Llandaff North: Gabalfa Primary School And Ysgol Glan Ceubal

Consultation Report

Project No: CO17000

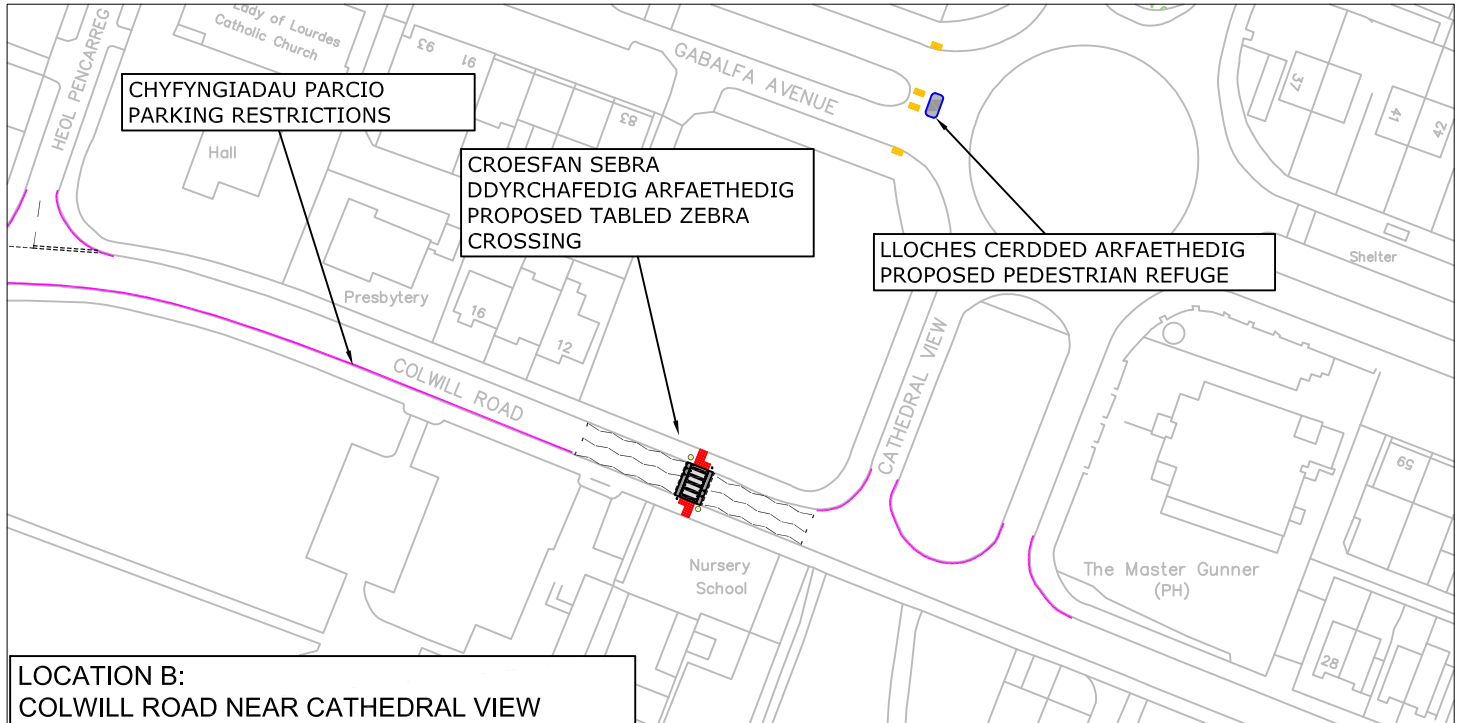
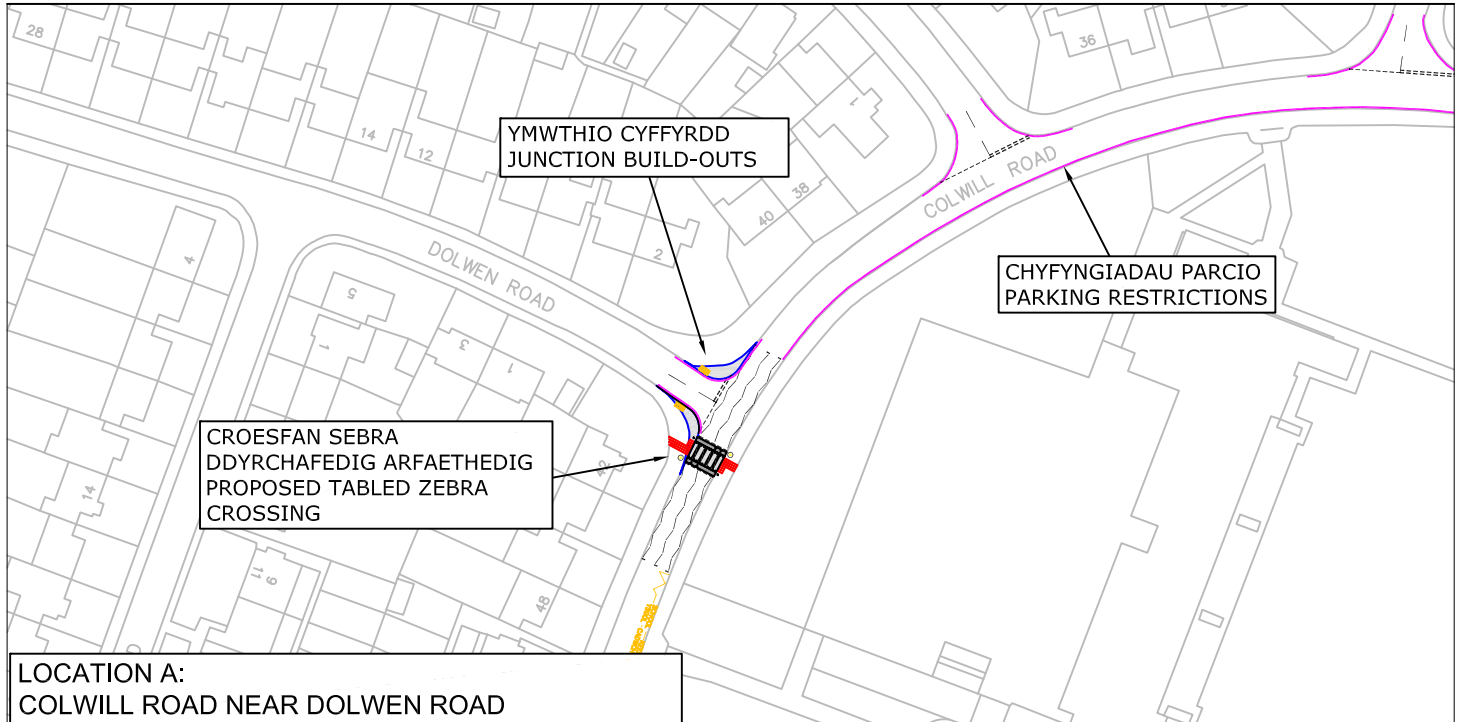
The resident was concerned about their driveway being blocked by parents parking near the school, and that the zig-zag road markings would reduce the amount of available parking.

The zig-zag road markings associated with the zebra crossing extend for no more than approximately 16 metres either side of the crossing location, and as such, any displaced parking will not be over a significant distance.

Cardiff Council is aware of the demand for parking and we take all measures to maximise the available space within these types of scheme. However, the safety of pedestrians and facilitating safe convenient pedestrian movement, particularly to and from schools, is considered very important. In accordance with the Council's policies and strategy, this takes precedent over parking provision. However, we will take these views into consideration and will see what can be done during the detailed design process to improve parking availability.
